Devon Strut of the LAA's Response to Exeter Airport's ACP following Post Consultation Local Engagement Meeting, 4th October 2017, 10.00 at Exeter Airport

Fig. 1 Post consultation airspace design with revisions

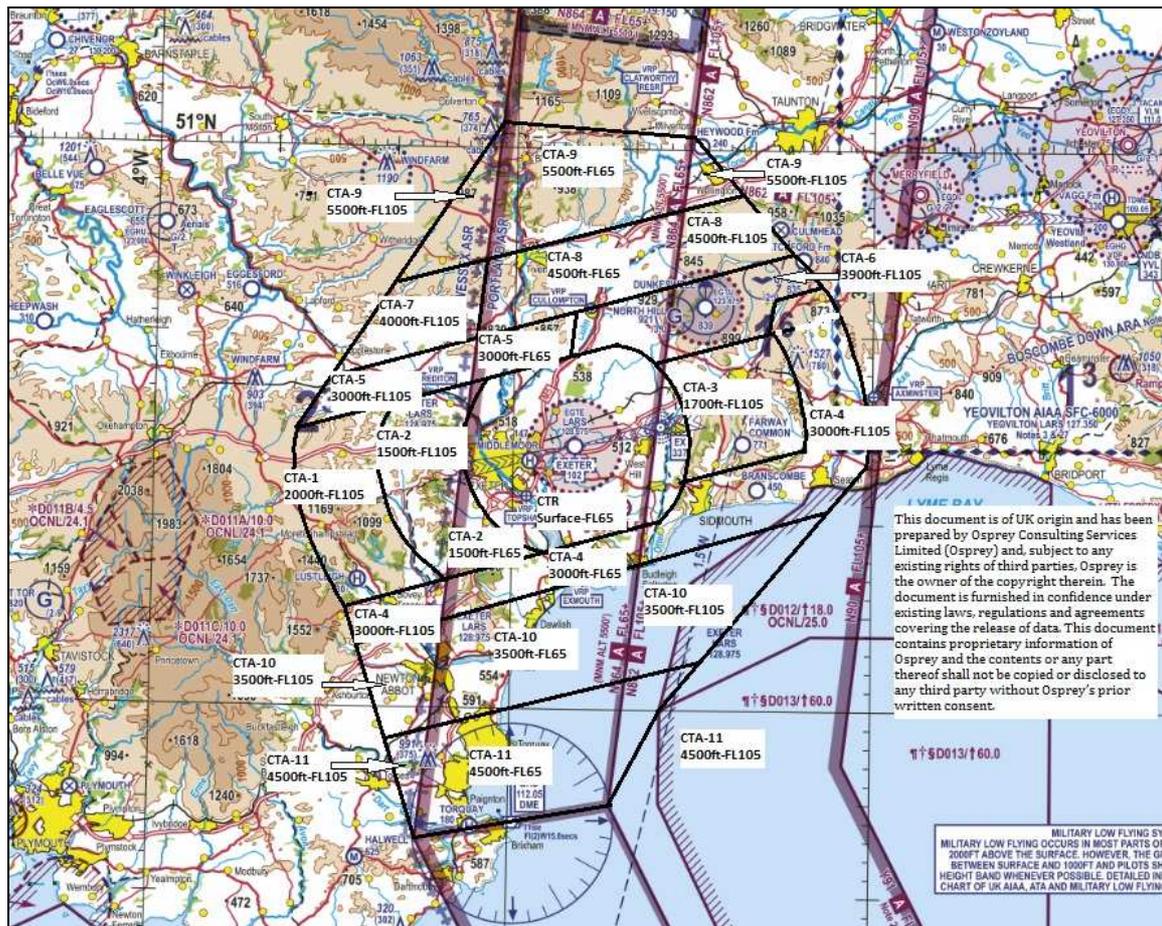
2.2 The MOD has objected to the proposed area CTA-10 in D012 in the SE corner of the plan. Consequently, the plan is to be revised as Danger Areas take precedence over Controlled Airspace.

- 2.10 DB will look again with Osprey at issues raised by Brendan Procter of DSFT regarding the proximity of the northern edge of proposed CTA-3 to the Dunkeswell

ATZ. As most of the reported cases of deconfliction over recent years had occurred on or adjacent to the ILS centrelines, the Strut suggested that these were the areas where CAT protection should be focussed and that CTA-3 should be narrower with its northern edge moved further south to avoid the Dunkeswell ATZ & parachute drop zone.

- 2.12 Devon Strut's concerns were reiterated re the base of CTA-1 to the west of the area and queried whether the ILS approach to RW08 could be amended from 3 degrees to match the 3.5 degrees used on RW 26 and hence allow the base of CTA-1 to be raised to 3,000ft. This would provide more headspace for GA traffic transiting the area where the ground level was ca 1,100ft amsl. DB dismissed this ILS procedure change as being too expensive.

- 2.13 The Strut acknowledged that the raising of the bases of CTA-3 to 1,700ft and that of CTA-6 to 3,900ft were helpful to GA but those benefits were countered by the added complexity that they introduced, an area of concern already raised by NATS. This would increase the workload of pilots transiting the area or arriving/departing Dunkeswell and increase the risk of traffic conflict and airspace infringements.

- 3.5 The revised airspace design (Fig.1 above), drawn up following comments from the consultation, was not shared with all consultees but its circulation was limited to a phase of local engagement with DSGC, DSFT and latterly with the Devon Strut who learnt of it from DSGC and then took the initiative in engaging with Exeter. Whilst acknowledging that this version was not likely to be the final design, as changes would be made following objections from the MOD, the failure to more widely share the revised design, which added even greater complexity to a proposal that NATS had criticised as being too complex, again illustrates a concerning element of subterfuge in the process.
